Review of Cleco Power's 2021 Draft IRP Report

LPSC Docket No. I-36175

Prepared for the Sierra Club

January 31, 2023

Figure 3. Offshore wind leveled cost of energy in 2030 (\$/MWh)

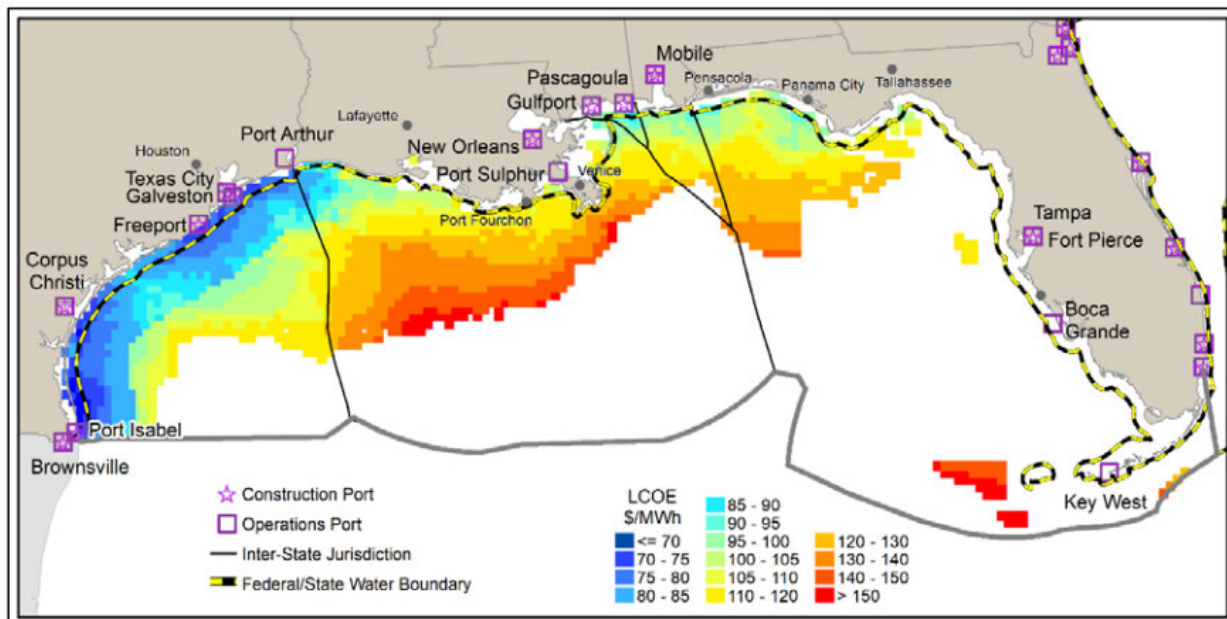
Secondly, the cost and capacity factor assumptions that Cleco has proposed to use for offshore wind are much more conservative than those used by other Louisiana utilities. Cleco's offshore wind cost assumptions are 200 to 300 percent higher than those used by other utilities in Louisiana, even after applying the 30 percent ITC. Cleco should re-evaluate the offshore wind cost assumptions it is using in this Draft IRP and should ideally use actual RFP responses from offshore wind developers to inform its cost assumptions for future resource planning exercises.

For the Western Gulf specifically, 1803 Electric Cooperative provided a figure in a recent slide deck that shows levelized cost-of-energy (LCOE) values are estimated to drop to between \$70/MWh–\$80/MWh for a project with an online date of 2030 (See Figure 2 below). Cleco's LCOE estimates for offshore wind are significantly higher, at a value of \$208/MWh. This high cost is driven by Cleco's high capital cost assumptions, as well as its conservative capacity factor assumption of 30 percent.⁴⁰ 1803 Electric Cooperative and Entergy Louisiana both determined that an average capacity factor of 38 percent would be appropriate for offshore wind in Louisiana.^{41 42}

Cleco should model renewable resources assuming that they can benefit from either the ITC or the PTC and should consider the additional tax credits available for energy communities. Cleco should also re-evaluate its cost assumptions, particularly for offshore wind, and benchmark its costs against similar utilities and recent RFP responses.
